M9010A-01

Safety Service Note

M9010A PXIe Chassis: 10-slot, 3U, 24 GB/s, Gen 3

POSSIBLE SHOCK HAZARD

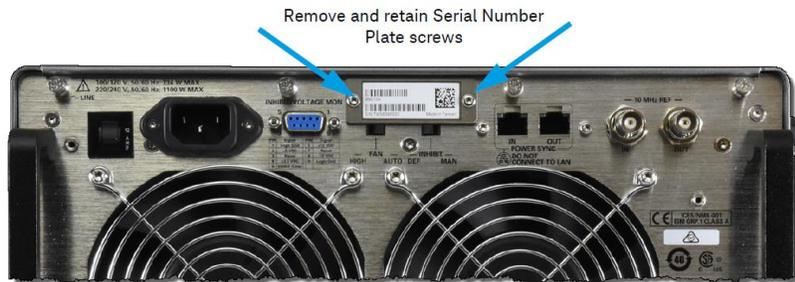
3. Loosen the eight captive screws indicated in the below figure. These screws are not removable; loosen them until they spring free from the chassis.

4. When all eight captive screws are loose, use the rear panel handles to pull the Rear Panel Assembly from the chassis.
